# Release Notes

Product: DL30

- Sleep Mode:

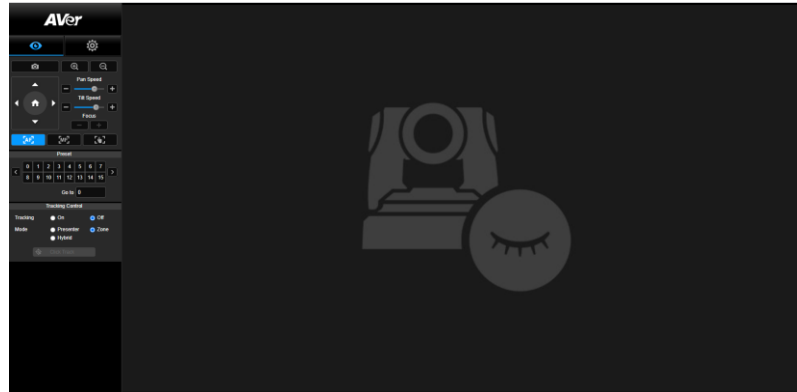
Firmware Version	V7.0.0022.29
Release Date	December 13, 2021
New Features	<ol style="list-style-type: none"><li>1. Support of hostname modification.</li><li>2. Support of import/export setting data.</li></ol>
Improvements	<ol style="list-style-type: none"><li>1. Improved the function of Effective Tracking Area.</li><li>2. Fixed the issue that when putting both hands on forehead, it may cause random tracking loss.</li><li>3. Fixed the issue that may take some time for software to response when using Zoom In/Out control with camera on Window 10 version 20H2 and later.</li><li>4. Fixed the issue that tracking will be disabled when using Microsoft Camera Application and DL30 is being used as the video source.</li><li>5. Modified the design of Sleep Mode, which are:<ol style="list-style-type: none"><li>A. Only can be enabled when USB only is chose as the camera video mode.</li><li>B. Added the option of "Turn on Tracking after Exiting Sleep Mode".</li></ol>A screenshot of the camera's settings interface. The 'Sleep Timer' section has radio buttons for 'Off', '10sec', '5min', '10min', and '20min'. Below it, a checkbox labeled 'Turn on Tracking After Exiting Sleep Mode' is checked. A red box highlights this checkbox and its associated text: 'Turn on Tracking After Exiting Sleep Mode' and 'Sleep mode can only be enabled when video mode is USB Only.' Below this is a 'Camera Selector' section with buttons for '1', '2', '3', and '4', where '4' is selected.<ol style="list-style-type: none"><li>6. Improved the design of Standby/Privacy Mode: camera status remains the same after exiting from Standby/Privacy Mode.</li><li>7. Supported the option of Presets other than Preset 1 when Auto Zoom is off.A screenshot of the camera's settings interface. The 'Auto Zoom' section has a checked checkbox. Below it, text reads: 'When Auto Zoom is off, camera stops zooming in/out automatically and shoots the presenter according to the shot size of the preset you choose.' Below this text is a dropdown menu showing 'Preset 1' with a downward arrow. A red box highlights the dropdown menu.<ol style="list-style-type: none"><li>8. Added exclusive UI on camera webpage when camera is under Sleep/Privacy</li></ol></li></ol></li></ol>

Mode.
